TEXAS COMMISSION ON ENVIRONMENTAL QUALITY

Subject: Texas Disposal Systems Landfill - Travis County
Municipal Solid Waste - Permit No. 2123
Permit Modification - Technical Review Completed
Tracking No. 28105718; RN102016698/CN600126932

Narrative of Proposed Modification

GRADING PLAN - COMBINED SURFACES
 PERMIT MODIFICATION
 TEXAS DISPOSAL SYSTEMS LANDFILL

ATTACHMENT
6-6

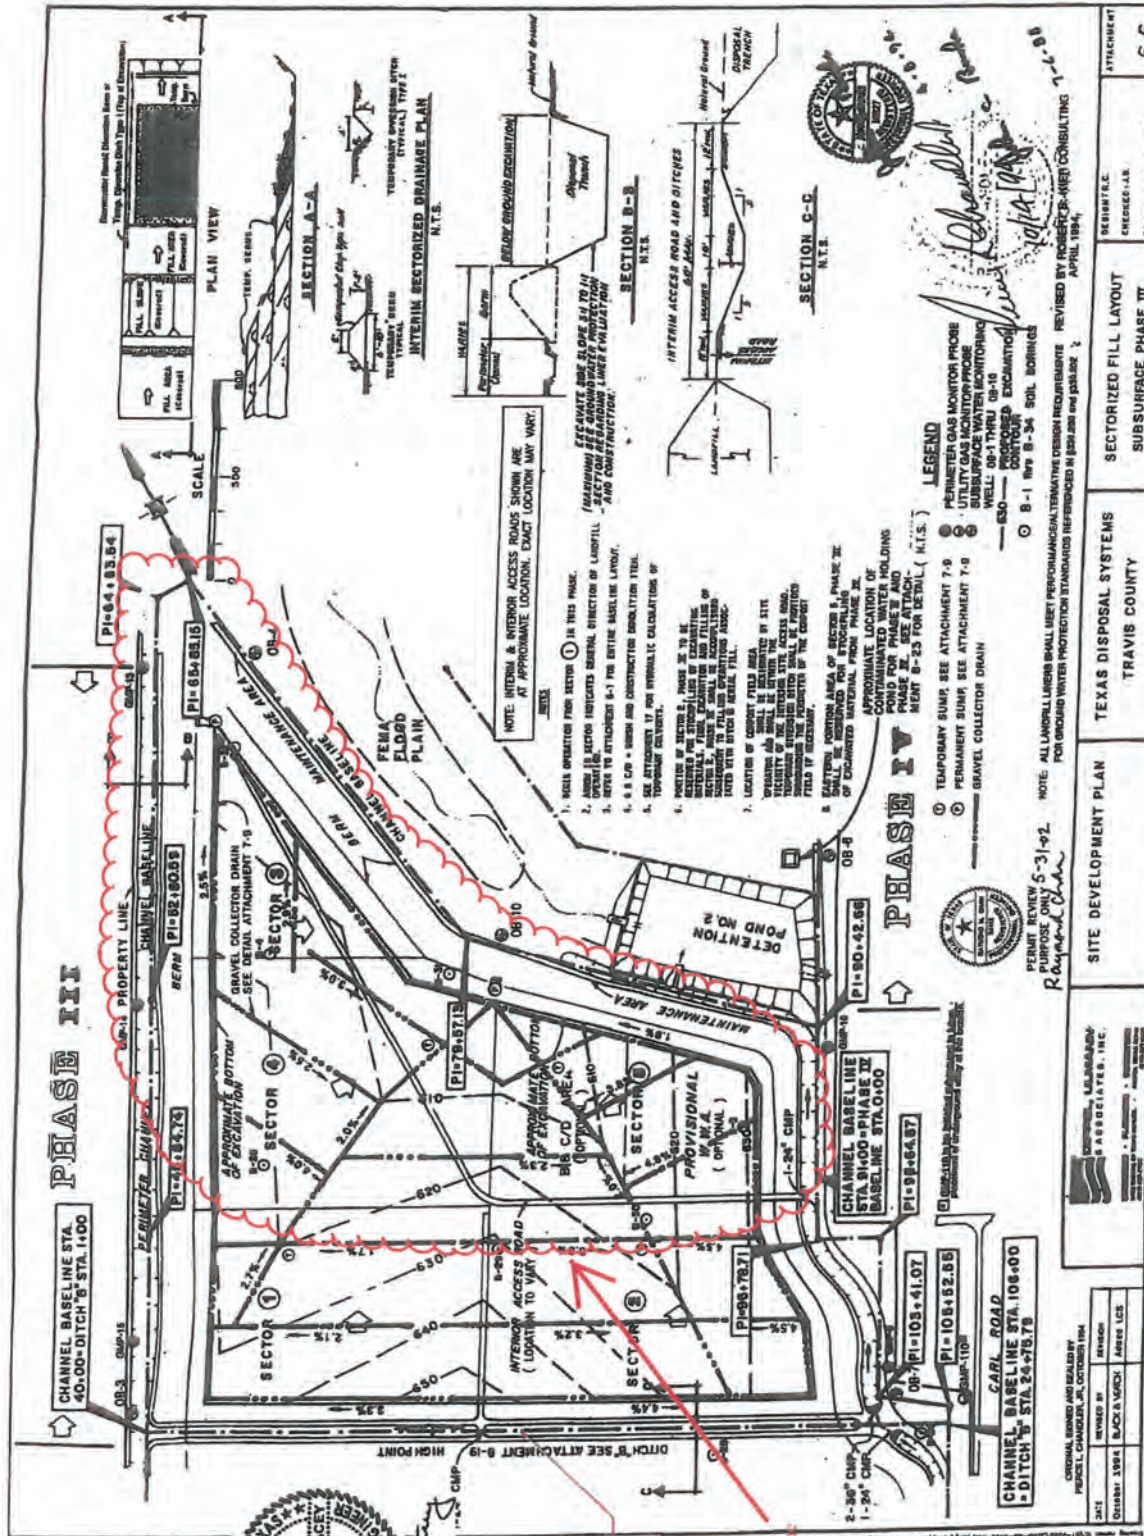
This portion of Attachment 6-6 is modified by Attachment 6-6.1 of the 2022 Modification Application

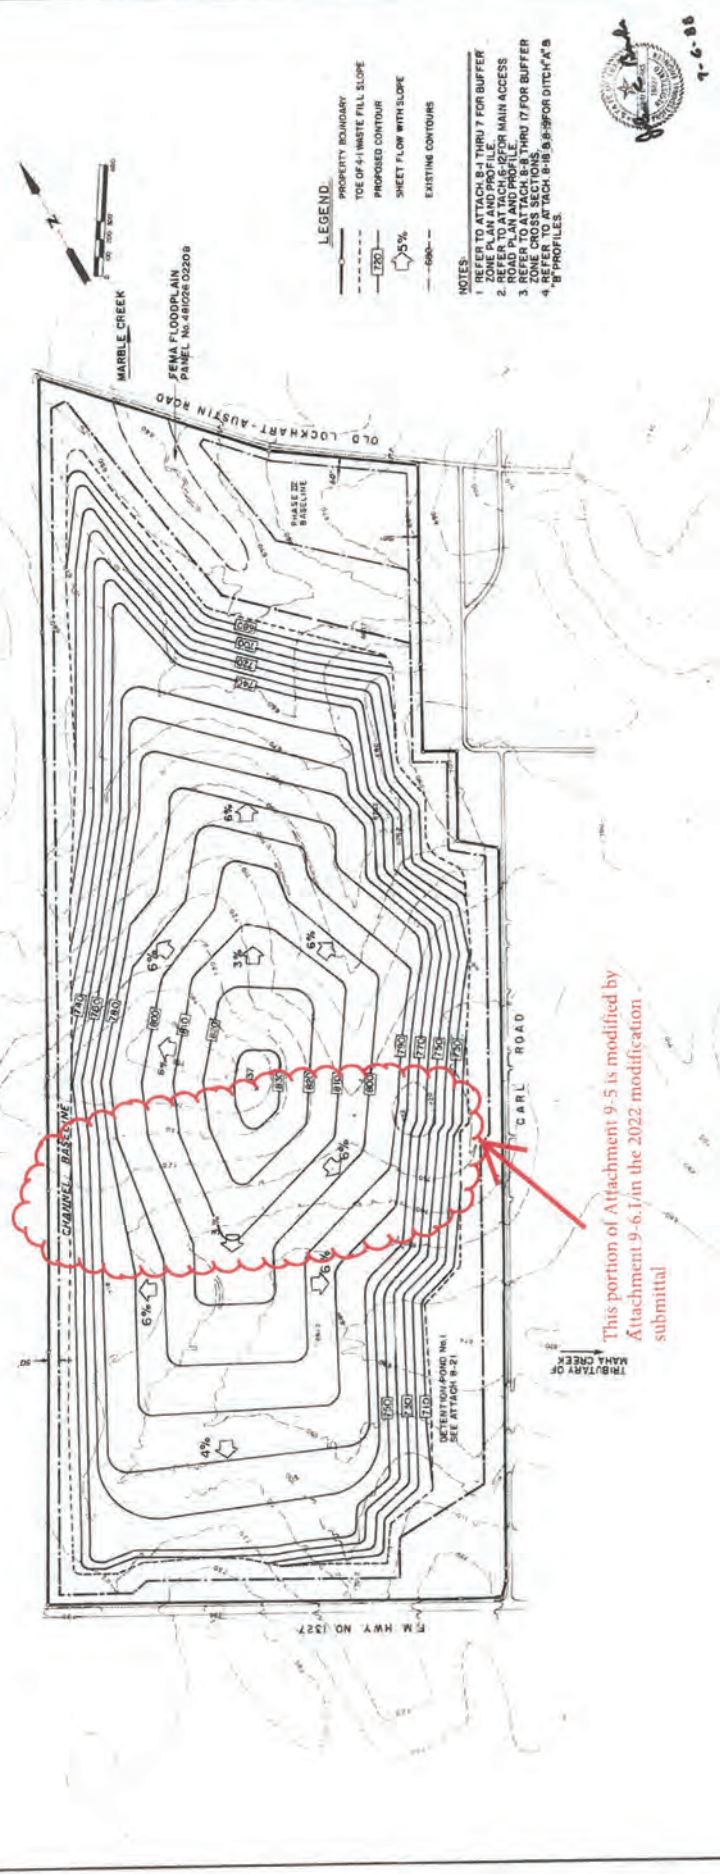
This portion of Attachment 9-5 is modified by Attachment 9-6.1 in the 2022 modification submittal

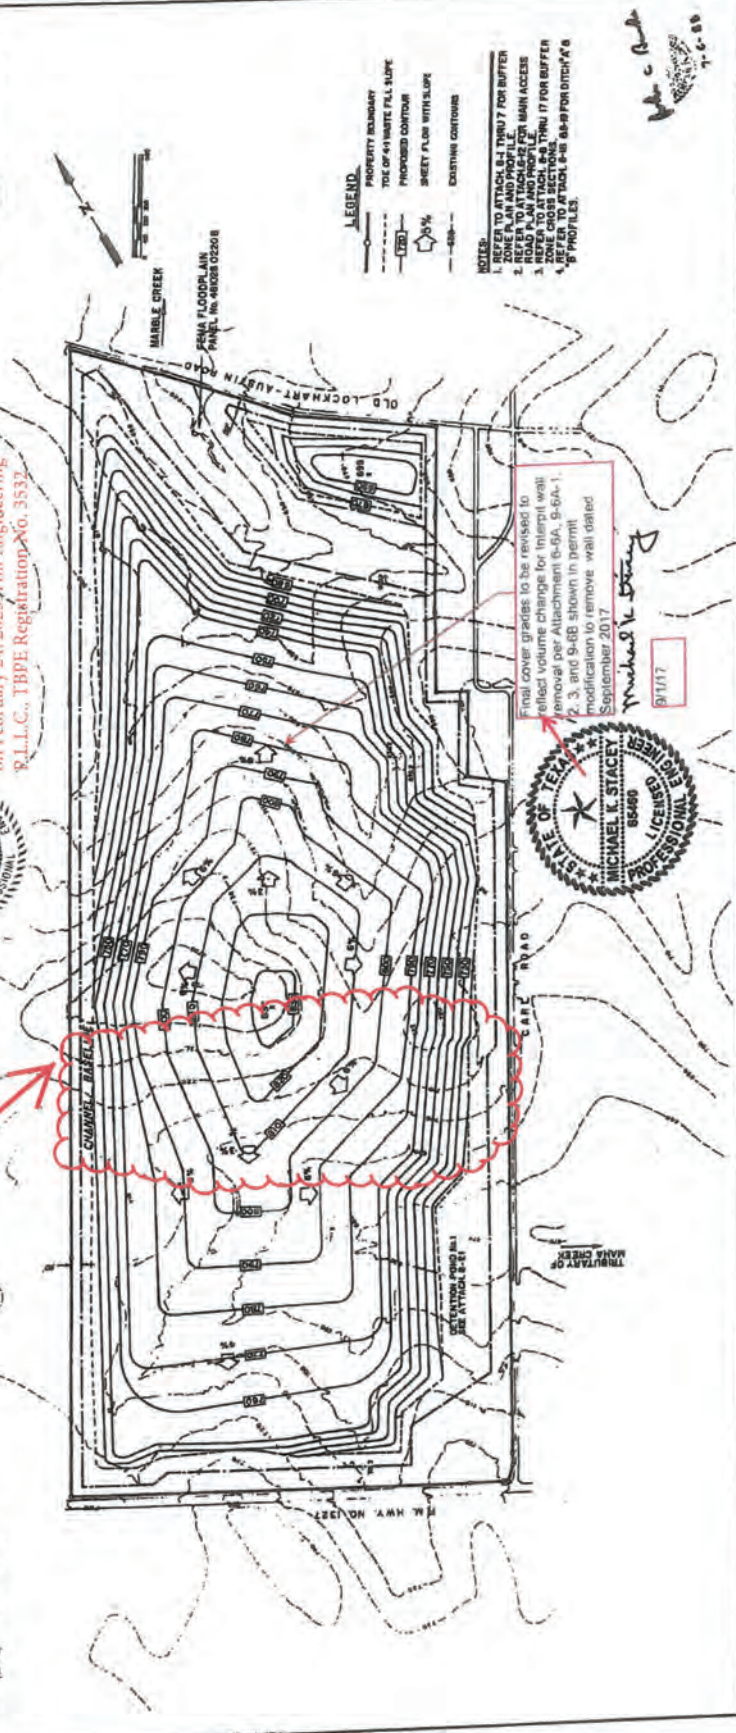
Final cover grades to be revised to reflect volume change for intercept wall removal per Attachment 8-5A, 8-5A-1, 8-5B, 8-5B-1, and 8-5B shown in permit modification to remove wall dated September 2017

Attachment 5-6.1.
 Subsurface Grades and
 Phase III/III Leachate Trenches
 and Permanent Sumps
 Texas Disposal Systems Landfill, Inc.
 Type I MSW Landfill, Creedmoor, Texas

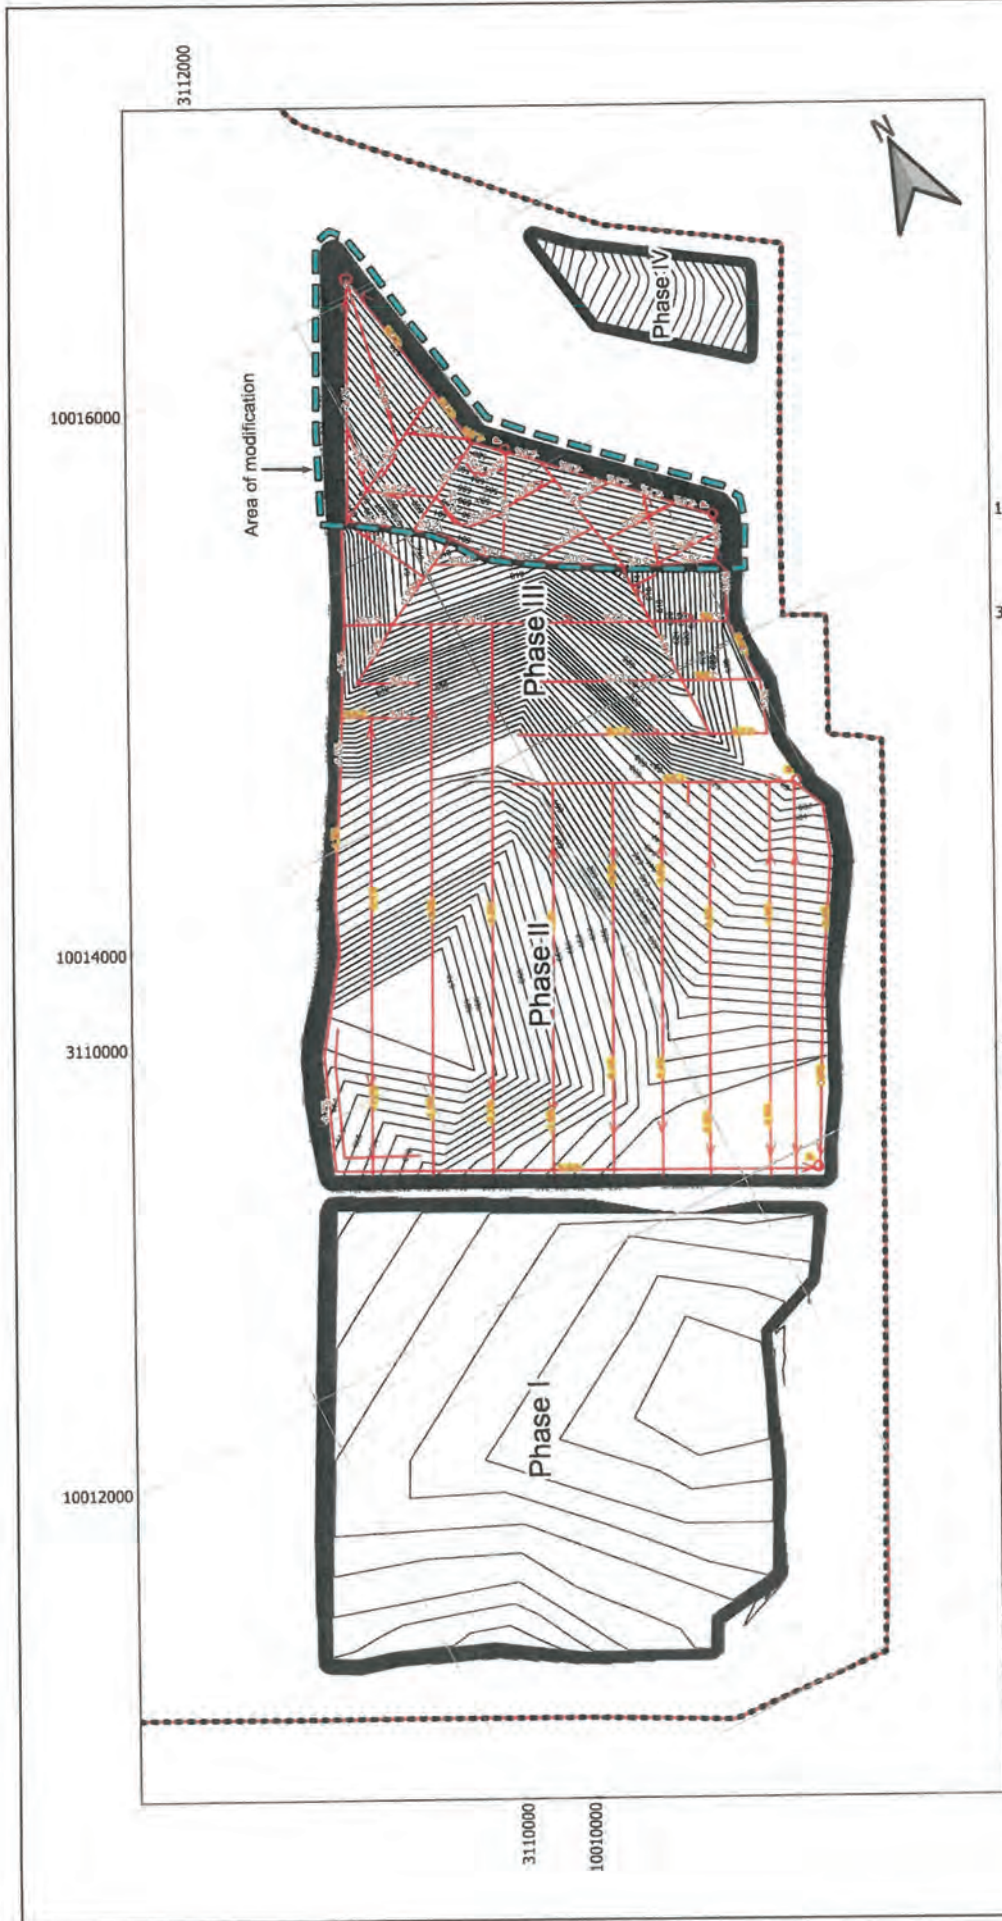
The proposed modification also improves the leachate collection system by lowering the area that will drain to a large sump that will allow for the improved collection of leachate from the Phase II/III waste unit as needed. The leachate trenches have been modified to provide more slope on the channels moving leachate to the permanent sump locations. This allows for leachate to flow more efficiently to the collection sumps for removal. A third permanent sump will be added on the northeast corner of the Phase II/III waste unit that allows for improved collection and removal of leachate since the leachate will not have to

travel as far as previously designed before being collected from the sump. These changes are illustrated on Attachment 6-6.1 –Subsurface Grades and Phase II/III Leachate Trenches and Permanent Sumps.

The modified grading plan is depicted in Attachment 6-6.1. Specifically, the grading plan for Phase III has been modified to alter subsurface grading deeper into the characterized in-situ liner in the northern portion of Phase III resulting in a volumetric waste disposal increase of 810,041 cubic yards.

Attachment 9-6.1.
 Landfill Completion Plan Contours

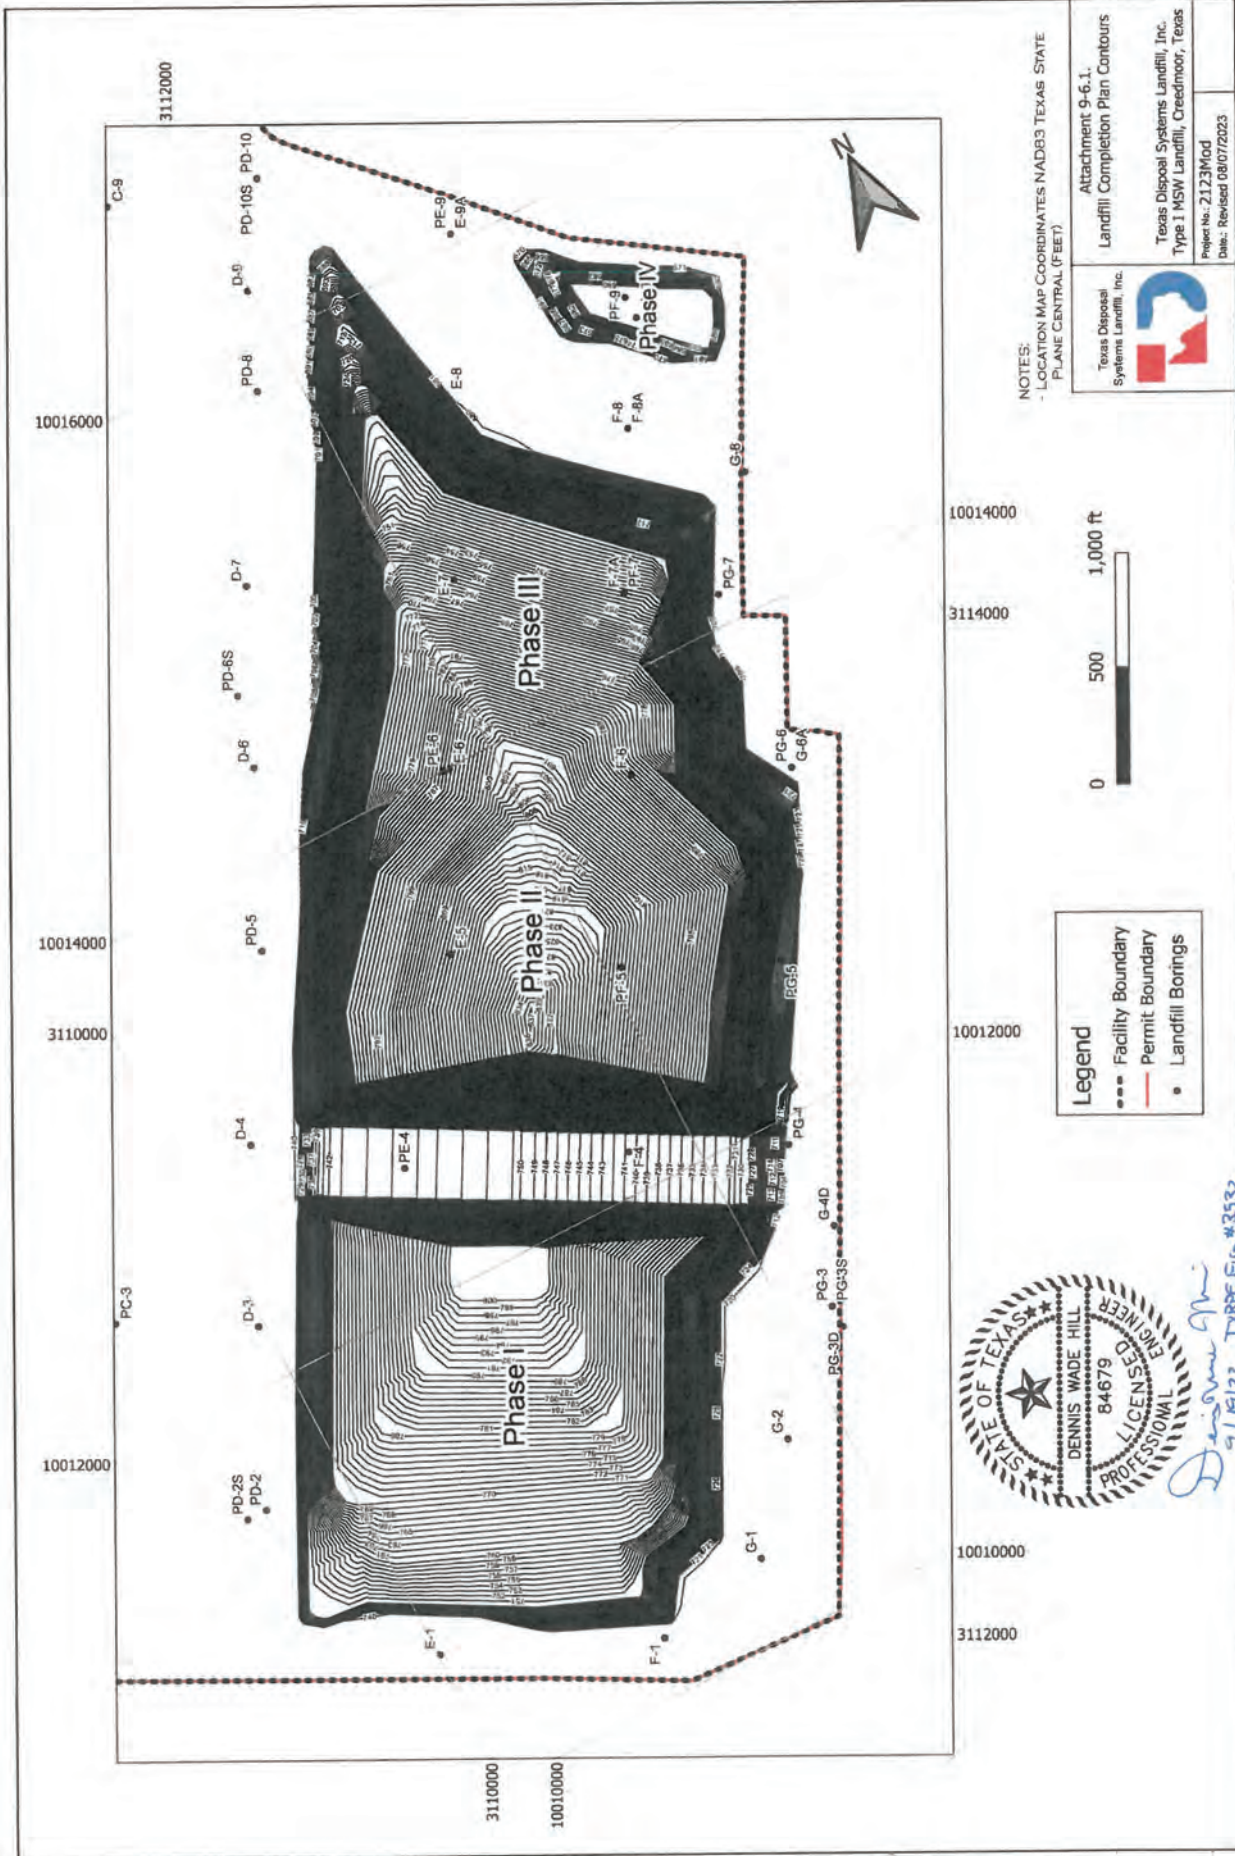
The proposed modifications to the landfill completion plan contours are shown in this submittal on Attachment 9-6.1, Landfill Completion Plan Contours. The proposed modification for changes to the excavation plan only affects Phases I through III and Ditch A. Currently fill in Sectors 1 and 2 within Phase III are underway. To accommodate increasing demand and future landfill planning it is beneficial to modify the excavation grade in Sectors 3, 4, and 5 of Phase III. The modified Phase III floor will have an elevation of deepest excavation (EDE) of 577 feet msl, which represents the elevation of the bottom of the lowest

The contours of the final cap on the north end of Phase III are being revised to match the contours that were included in the original Permit 2123 application. Returning the final cap contours in this area to the originally approved contours, results in flows from this area matching the flows included in the original Permit 2123 documentation and resulting in no increase in peak flows.

Modifications to the final contours proposed in this application at the peak of the landfill cap and over Ditch A will improve the movement of water from the top of the completed landfill in this area. Water flowing from the high point of the landfill will be able to move into the lowered portion of Ditch A. This same water previously would have flowed across the cap to the east and west and down the side slopes. The time of concentration - which is the time required for water to flow across the landfill - increases and thus results in a decrease of peak discharges. Table 1.4 is provided on page 7A comparing the flows in the watersheds affected by the 2022 modifications to the flows from the approved MSW Permit 2123. These updated flows reflect current design specifications for the City of Austin Zone 1 region. The perimeter channels will either receive the same flows as originally designed or decreased flows resulting from this modification, and therefore remain adequate to carry the flows.

The proposed modifications to the landfill completion plan contours are shown in this submittal on Attachment 9-6.1, Landfill Completion Plan Contours.
